UNITED STATES
NUCLEAR REGULATORY COMMISSION

MEMORANDUM FOR: Docket No. 40-1162

SUBJECT: PROPOSED AMENDMENT TO SOURCE MATERIAL LICENSE SUA-56 TO
REVISE THE APPROVED DISPOSAL AREA RECLAMATION AND CLOSURE
PLAN FOR WESTERN NUCLEAR, INC.'S SPLIT ROCK MILL NEAR
JEFFREY CITY, WYOMING

(MODIFIED FROM WNI SUBMITTALS)

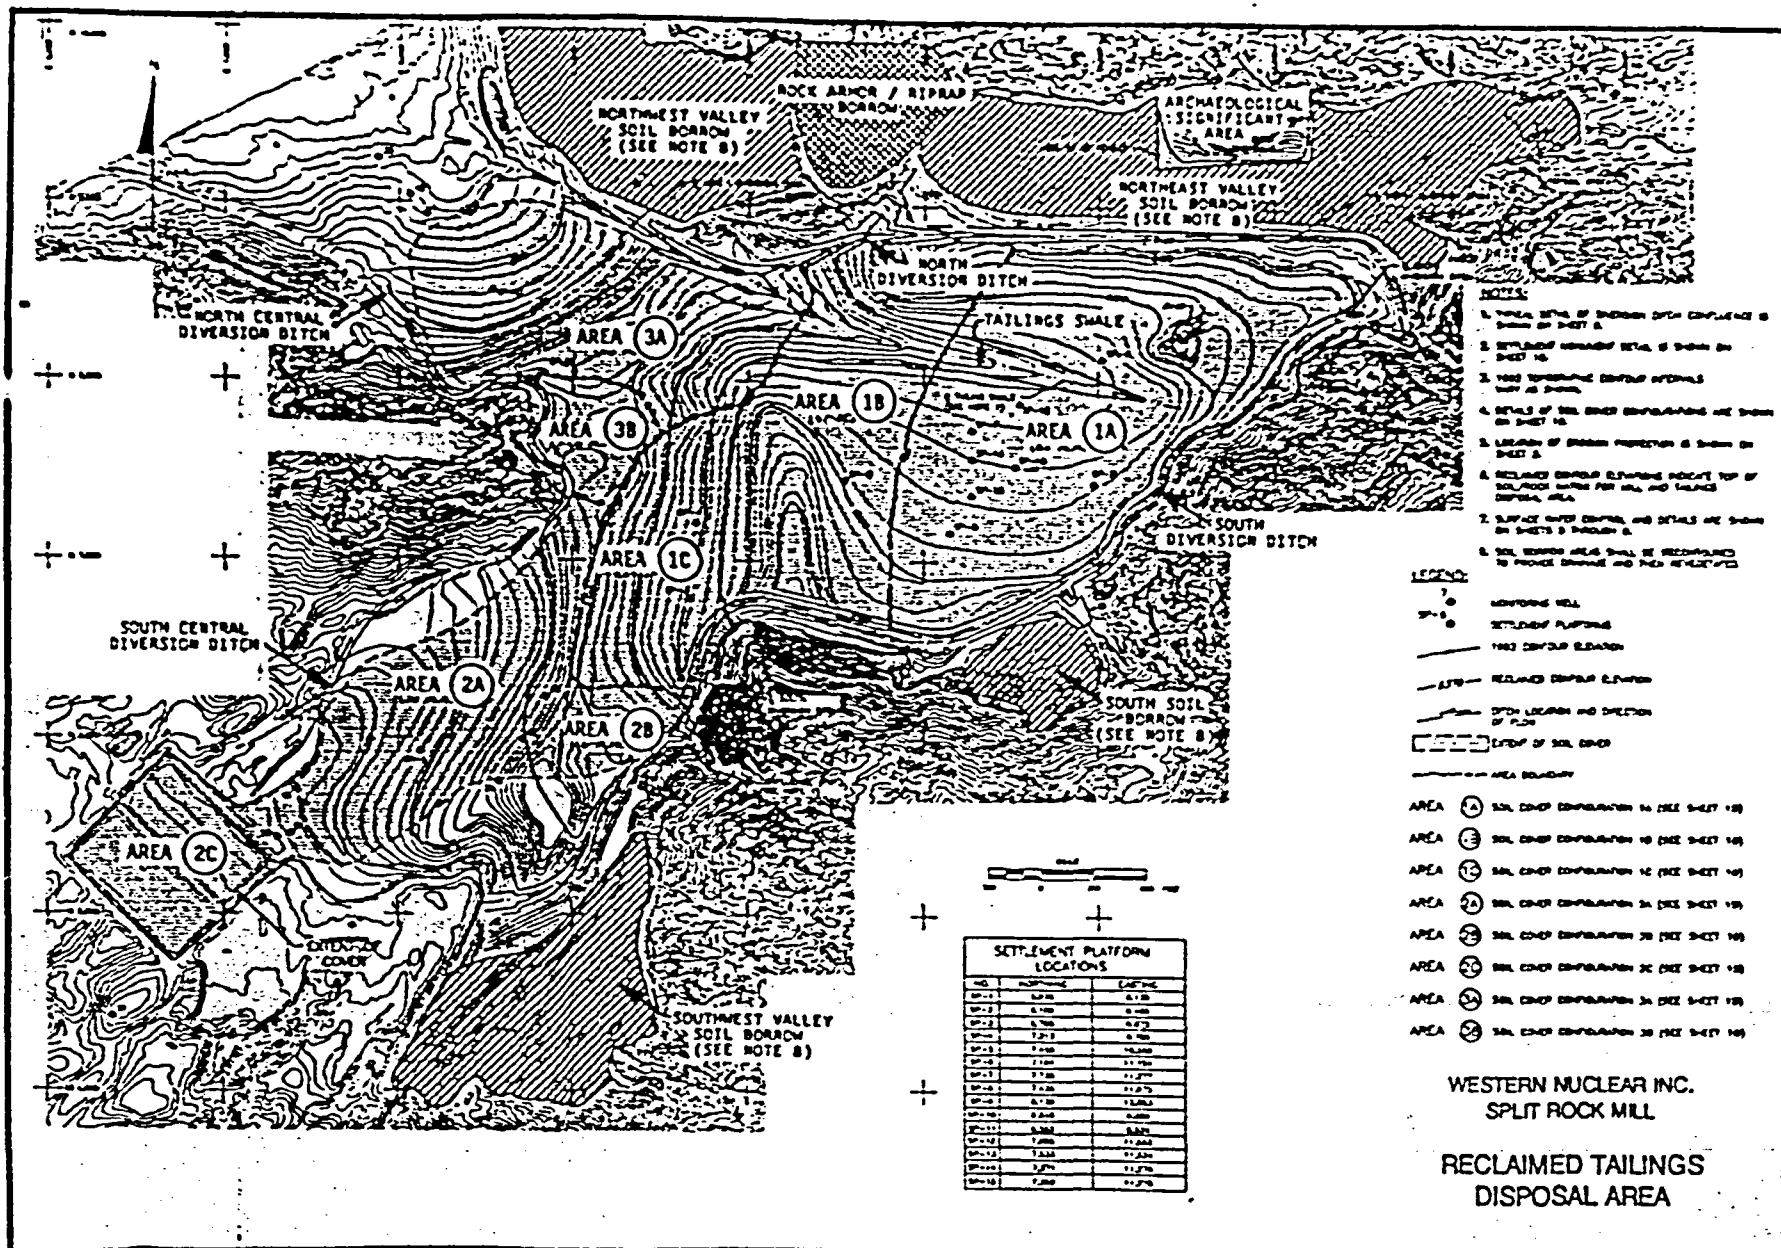
About 5.3 million tons of tailings are located in the old tailings pond and alternate tailings area. The remaining 2.4 million tons are contained within the new tailings area. These tailings will be reclaimed in place as shown on the attached figure. The tailings will be covered with windblown material, a radon barrier which will also reduce infiltration, and a soil/rock erosion protection cover. Flows from upstream drainages will be routed to the north and south of the disposal areas in diversion ditches.

As shown on the attached figure, and on Figure 5, Drawing No. 91-225-E54, (Addendum A to Revision 5), the surface of the tailings area will be regraded to drain into a central swale on top of the pile. To protect against erosion, the pile top will be covered with a layer of compacted rock and soil to form a soil/rock matrix, and the swale will be covered with riprap (rock). The heights of the two tailings embankments will be reduced by as much as 30 feet and the slopes, which are about 4H:1V, will be regraded to much flatter configurations of about 10H:1V and 20H:1V. Four rock-lined (riprapped) ditches; the North Diversion Ditch, the South Diversion Ditch, the North Central Diversion Ditch, and the South Central Diversion Ditch, will divert

| For design purposes, the reclamation area was divided into seven areas. As shown on the attached figure, Areas 1A and 1B represent the east and west new

The radon attenuation barrier is comprised of an imported clay layer (Cody Shale) and a borrow soil layer placed over the clay. The onsite soil borrow areas are shown on the attached figure and on Figure 3, Drawing No. 91-225-E52 (Addendum A to Revision 5). To obtain representative parameters, 132 samples were taken from the 8 borings and 14 test pits shown on Figure 1 (Addendum A to Revision 5), and composited into 3 representative samples. Gradation tests

Soil/Rock Matrix - The soil/rock matrix shall consist of sized angular granite and soil obtained from the specified onsite borrow sources shown on the attached figure and on Figure 3, Drawing No. 91-225-E52 (Addendum A to Revision 5); soil obtained during excavation of the ditches; or alternate sources approved by the licensee. The soil must be acceptable as specified above. The rock shall meet the scoring criteria discussed in Appendix D of the Staff Technical Position on Erosion Protection (NRC, 1990) (Section 5.2.1, Addendum A to Revision 5). The rock material shall be angular, resistant to abrasion and weathering, and shall be free from cracks, seams, and other defects that would tend to increase weathering by water and frost action. The rock shall be well graded and sized as specified in Table 2C of Addendum A to Revision 5.
